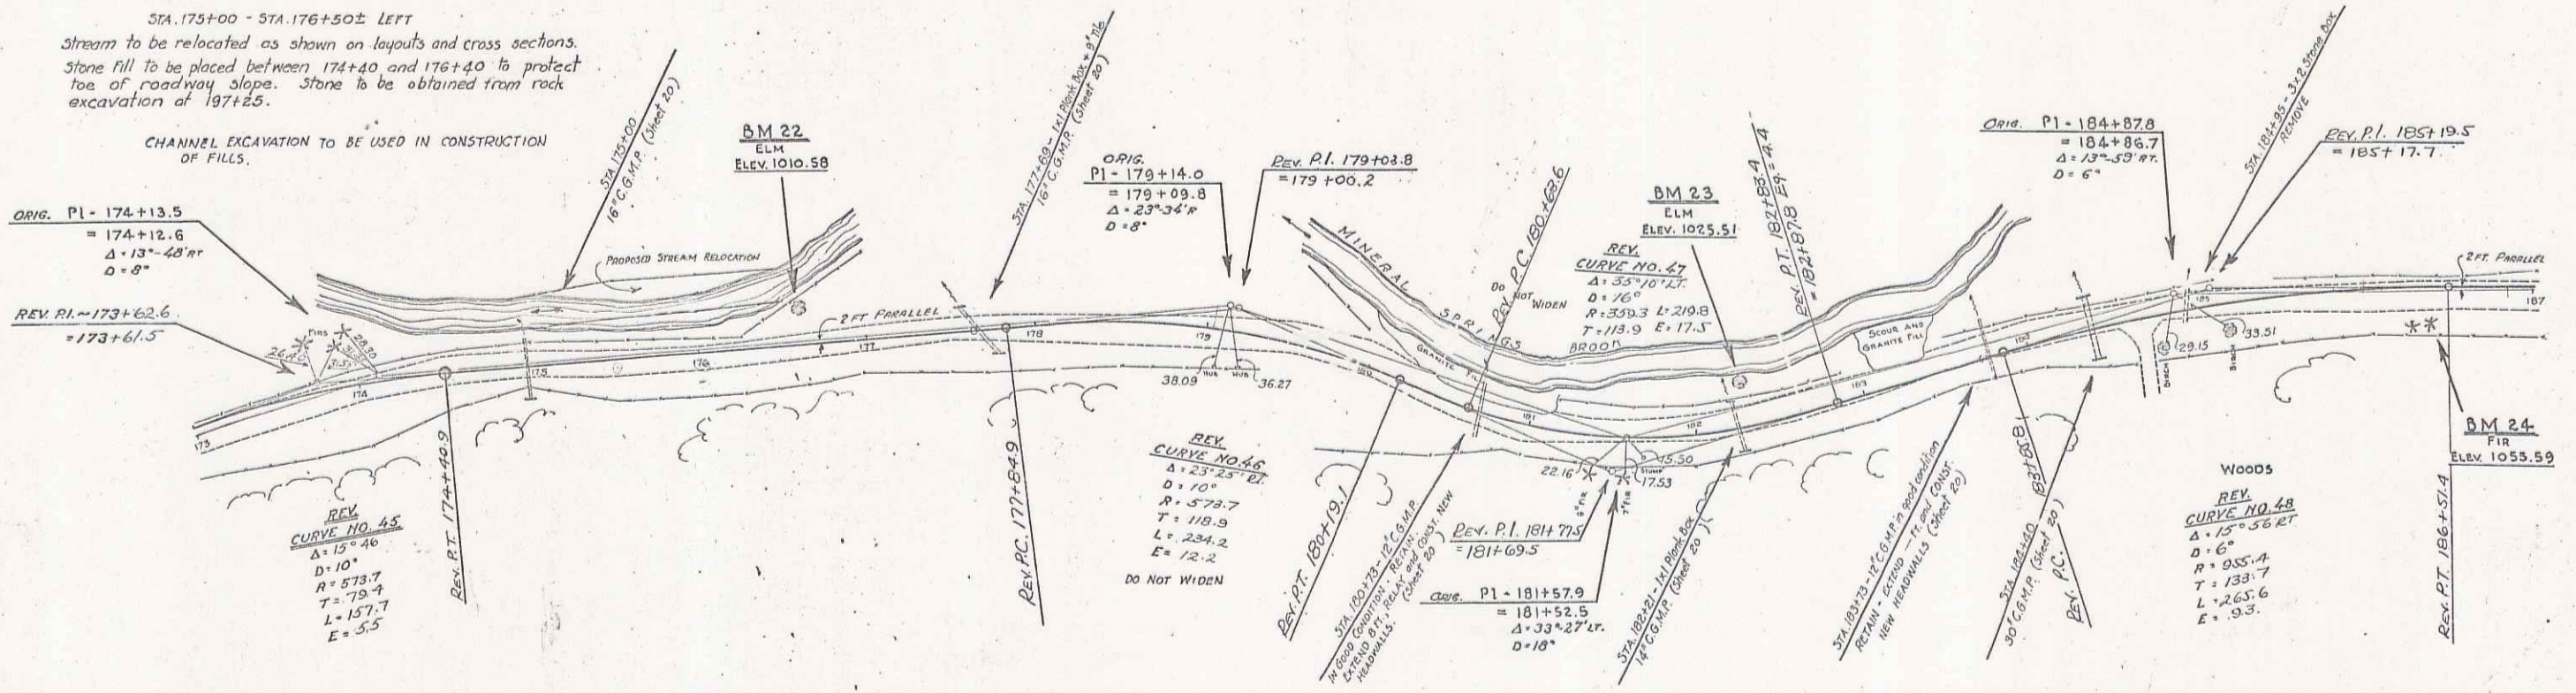
REVISION MADE JUNE 21, 1930 ACCORDING TO STAKING-OUT NOTES
CURVE 45
P.I. WAS 173+530 = 173+728
P.C. WAS 172+594.4
P.T. WAS 174+54.4
Δ WAS 16° 00' ET
T WAS 80.6
L WAS 160.0
E WAS 5.6

REVISION MADE JUNE 23, 1930 ACCORDING TO STAKING-OUT NOTES
CURVE 46 CURVE 47 CURVE 48
P.I. WAS 179+179 = 179+179
P.C. WAS 178+107.9
P.T. WAS 180+233
Δ WAS 28° 45' ET
T WAS 80.6
L WAS 160.0
E WAS 5.6
P.I. WAS 181+579
P.C. WAS 180+137.0
P.T. WAS 182+162
Δ WAS 40° 31' LT
T WAS 109.4
L WAS 218.8
E WAS 20.7
P.I. WAS 185+116 = 185+116
P.C. WAS 183+139.9
P.T. WAS 186+154.1
Δ WAS 16° 45' ET
T WAS 140.7
L WAS 281.4
E WAS 10.3
